## Product Change Notice

NiPdAu pre-plated lead-frame

- AFBR-2555ARZ
- HFBR-2555AFZ
- AFBR-1555ARZ

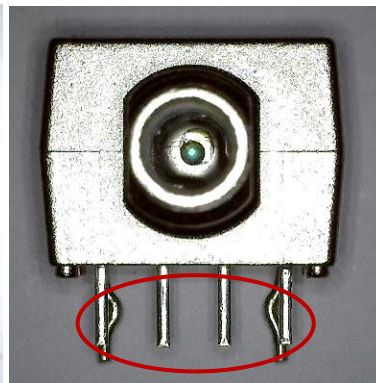
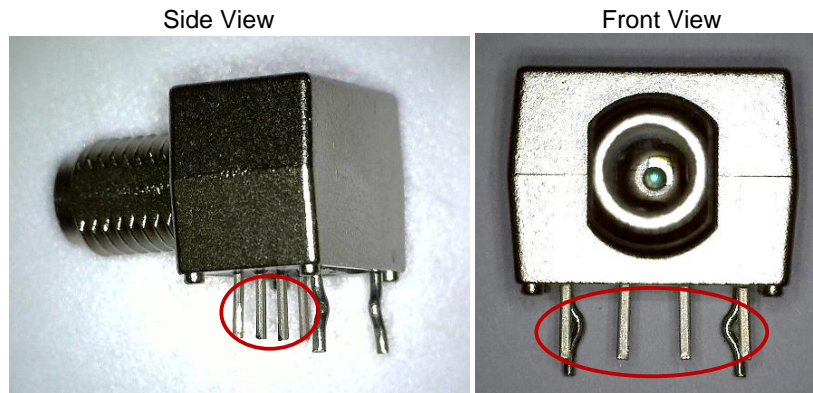
**Description and Extent of Change:**

Qualify NiPdAu pre-plated lead-frame to adopt industry standard, improve product reliability, product cycle time and to simplify lead-frame supply chain.

Active pins (pin5, pin6, pin7 and pin8 in red circle): Affected by changing to new NiPdAu lead-frame finish.

Staple pins or Metal shield mounting pins (pin1, pin2, pin3 and pin4): No Change.

Eliminate additional solder dip process by implementing NiPdAu Pre-plated lead-frame to improve product reliability, product cycle time and to simplify lead-frame supply chain. The NiPdAu pre-plated lead-frame has been qualified and used in other Broadcom industrial products since year 2015. Lead frame layout and base material remain unchanged.
